# CITY OF ALBUQUERQUE

PLANNING DEPARTMENT – Development Review Services

RE: **Copper Pointe  
Grading and Drainage Plan  
Engineer's Stamp Date 9-24-15 (File: K21D009H3)**

# COPPER POINT GRADING AND DRAINAGE

DROP INLET DETAIL

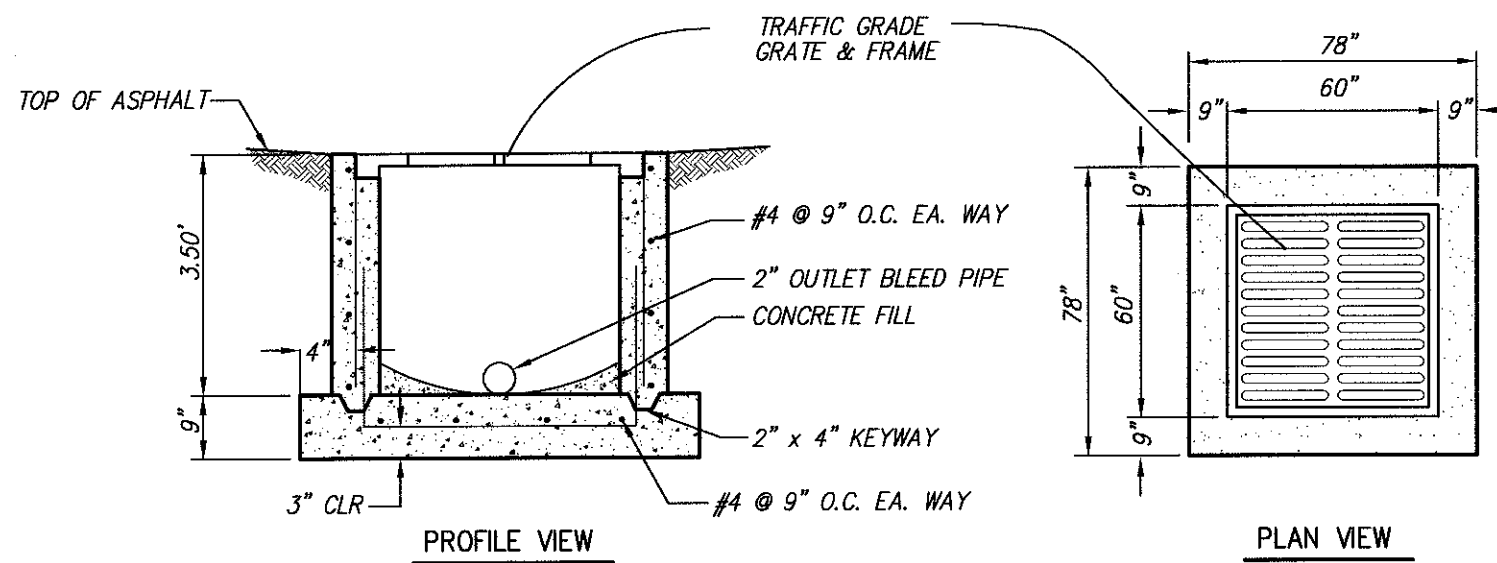
1. The first flush volume is shown to be bled into an existing 96" storm drain. The first flush needs to be retained on site, in a manner that infiltrates to the subsurface.
